Appl. No. 10/573,331
Amdt. Dated December 22, 2008
Reply to Office Action of June 25, 2008

Amendments to the Drawings:

REMARKS/ARGUMENTS:

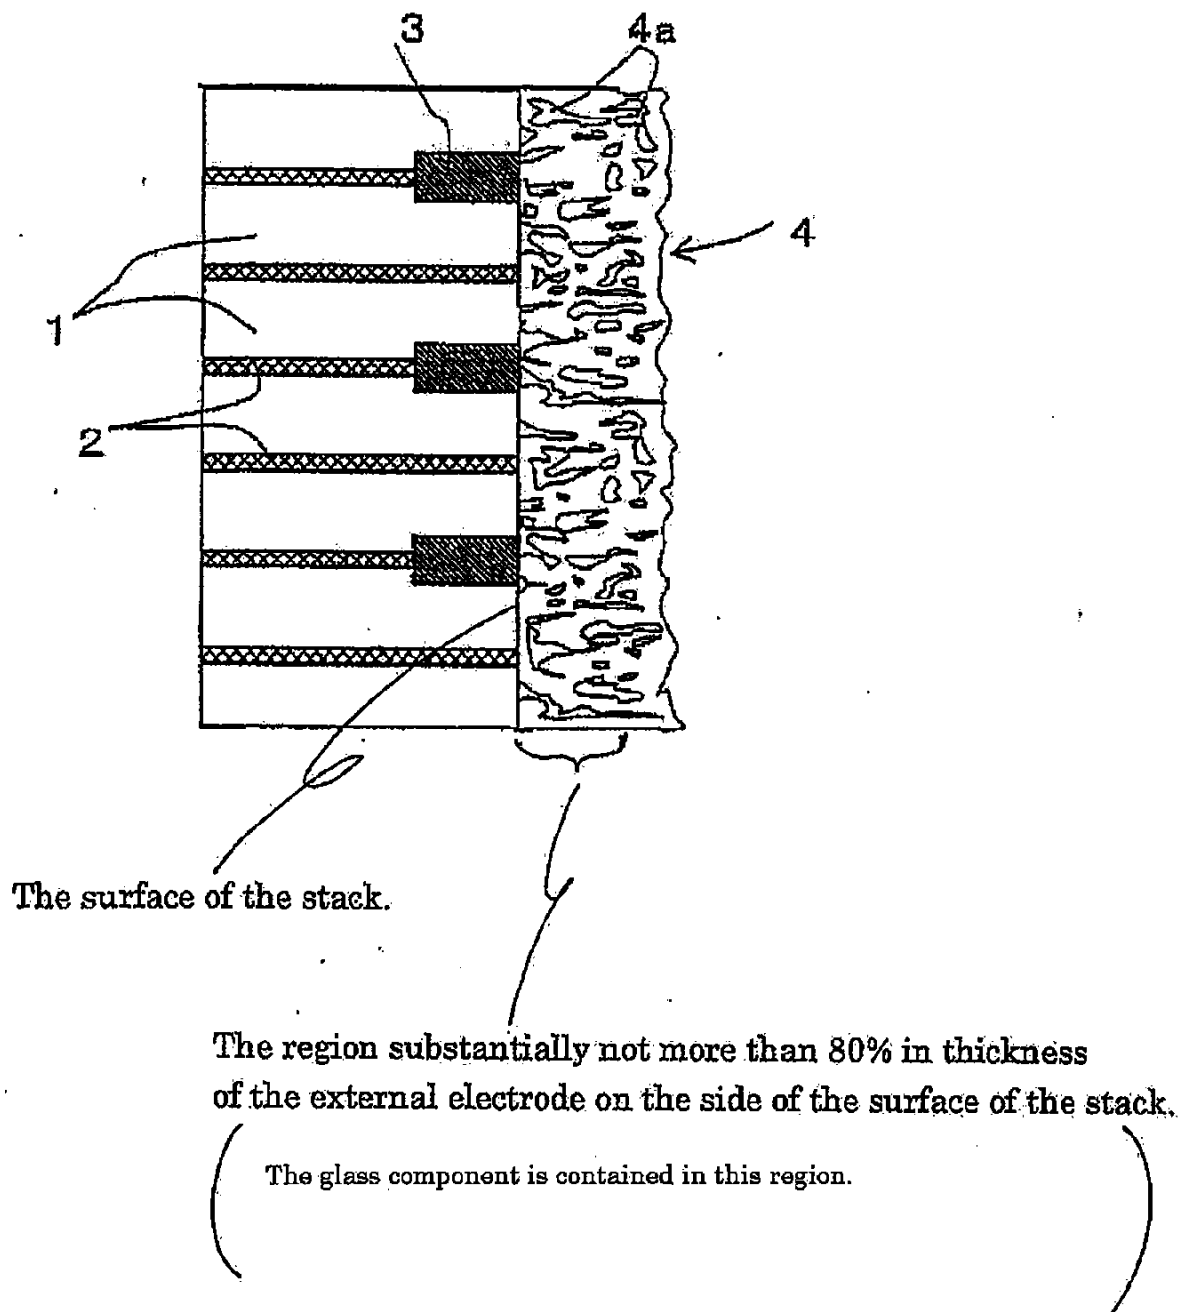
The Office states with respect to claim 56,

“It is unclear what is meant by ‘wherein the glass component contained in the external electrode exists in a region substantially not more than 80% in thickness of the external electrode on the side of the surface of the stack’.”

In response, Applicant changed “wherein the glass component contained in the external electrode exists in a region substantially not more than 80% in thickness of the external electrode on the side of the surface of the stack” to -- wherein the glass component is contained in a region substantially not more than 80% in thickness of the external electrode on the side of the surface of the stack--.

Claim 56 is further explained by the diagram below. Withdrawal of this rejection is thus respectfully requested.

Fig. 8A

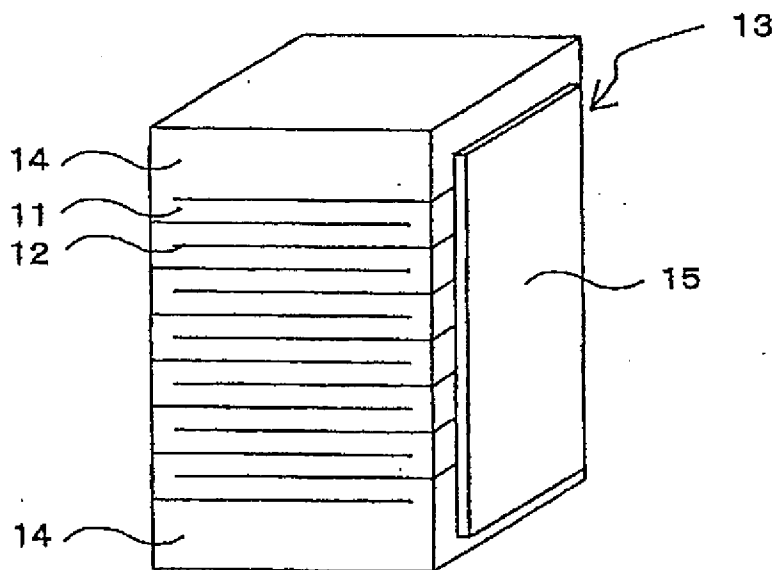
The Office states, "Figures 8A, 8B, and 9 should be designated by a legend such as --Prior Art-- because only that which is old is illustrated." In response, Applicant amended Figures 8A, 8B, and 9 to include the legend --Prior Art--. Withdrawal of this objection is thus respectfully requested.
